**AGENDA ITEM:** Discussion of Morgan Falls Road Improvement Project Elements

ITEM: Discussion of Morgan Falls Road Improvement Project Elements

**A RESOLUTION TO ALLOW THE CITY MANAGER TO EXECUTE A SUPPLEMENTAL AGREEMENT ON THE CONTRACT FOR DESIGN SERVICES FOR CIP PROJECT T-0034, MORGAN FALLS ROAD IMPROVEMENTS**

# MORGAN FALLS ROAD UPDATE

ALTERNATE WATER QUALITY TREATMENT  
OVERLOOK PARK

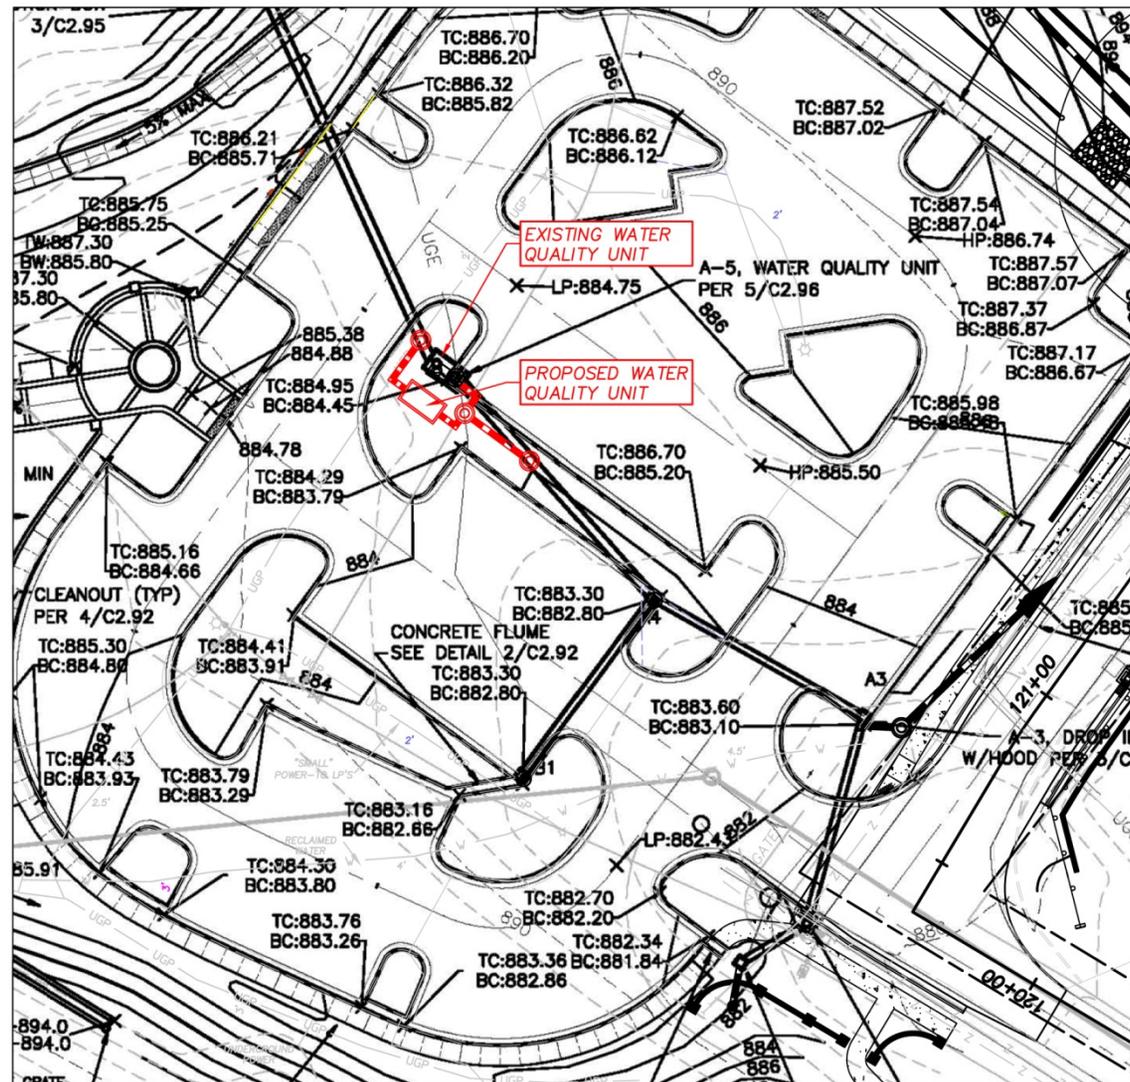
# Option#2 - Parallel oil/grit separator inside parking lot (Approximate cost \$53K)

Existing 36" tree will be impacted with widening project and especially if the raingarden option is selected

# Proposed Road Section

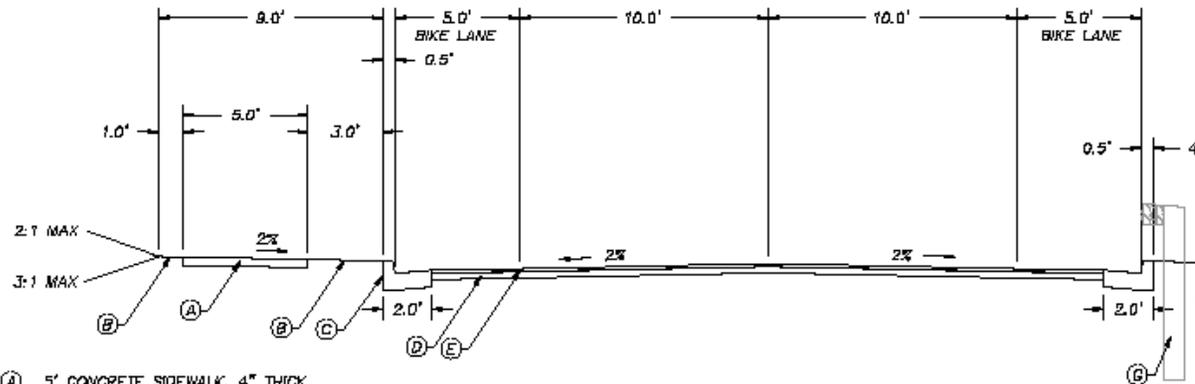
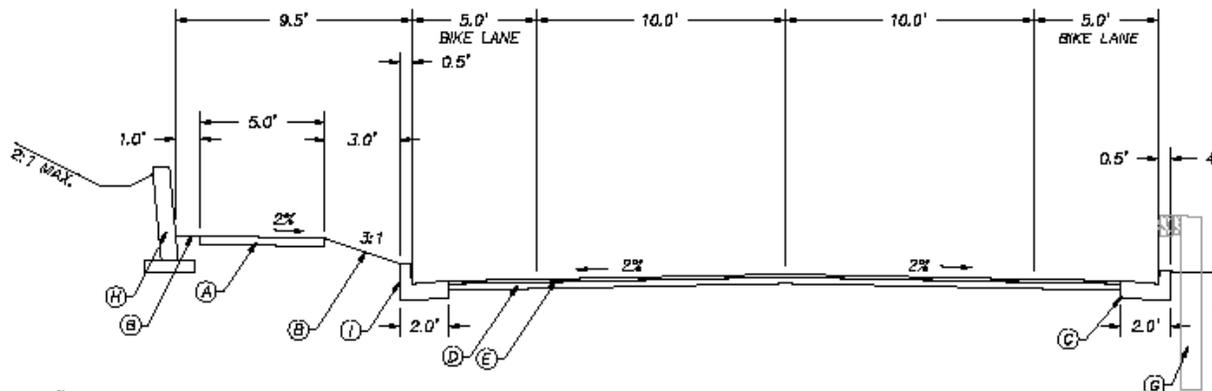
- ▣ Current design – two dedicated bike lanes (3.5' wide) and 5' wide sidewalk on northern side of road against walls
- ▣ Proposed design – remove 7' width from asphalt paving and 5' sidewalk against wall base, incorporate 10' wide multi-use path on southside overlooking golf course and wooded areas
